**ENVIRONMENTAL ASSESSMENT
TO ACCOMPANY A SECTION 75W
APPLICATION FOR
Proposed Modifications to MP 07_0093
At
Lot 5, Interlink Industrial Estate
Mamre Road
Erskine Park**

ADDENDUM

**Prepared for
Goodman Limited**

Job No. 11150A
EA-Addendum Final.doc
February 2012

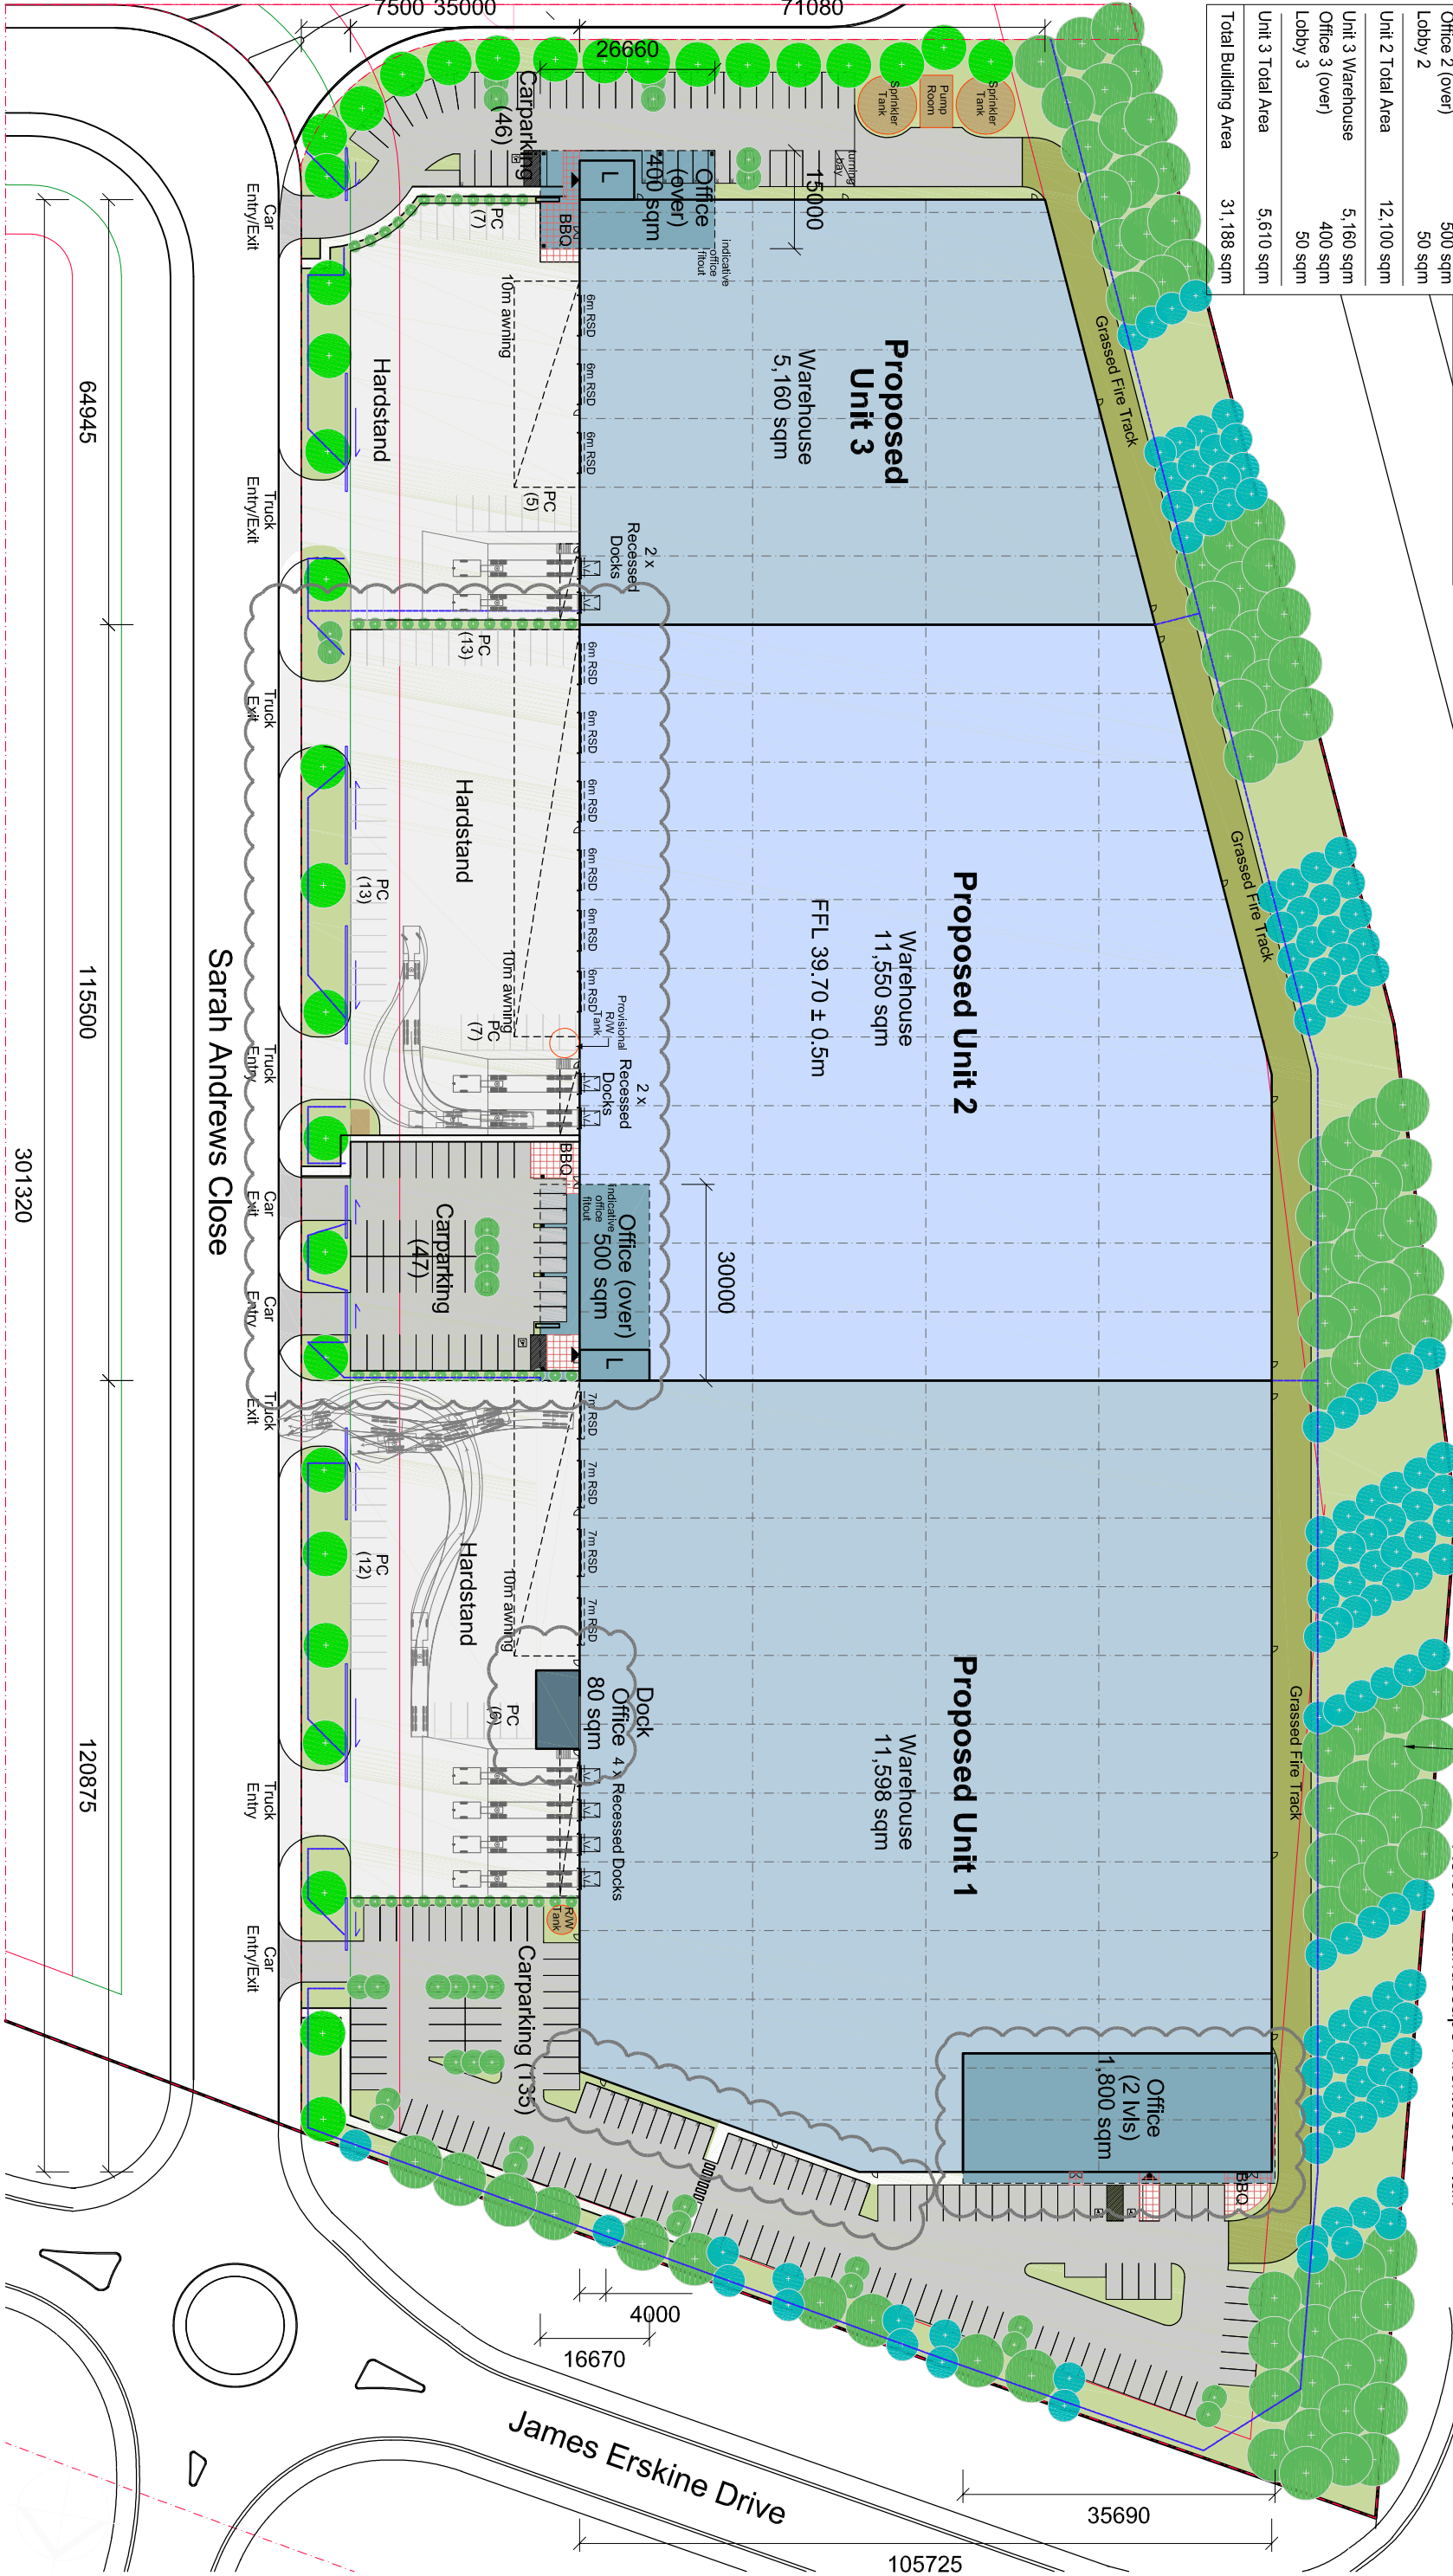
Unit 1

- Warehouse Gross Floor Area (GFA) decreases from 12,035m² to 11,598m²;
- Office GFA increased from 1,167m² to 1,800m²;
- Dock Office shifted north to be in between flush and recessed docks;
- Dock Office area increases from 60m² to 80m²;
- Car parking numbers increase by 20 spaces, from 115 to 135 spaces; and
- Provisional car parking increases from 5 spaces to 18 spaces.

Unit 2

- Office and associated car parking shifted towards northern end of the loading area;
- Flush and recessed loading docks shifted towards the southern end of the loading area; and
- Provisional car parking increases from 20 spaces to 33 spaces.

Unit 3

- No change.
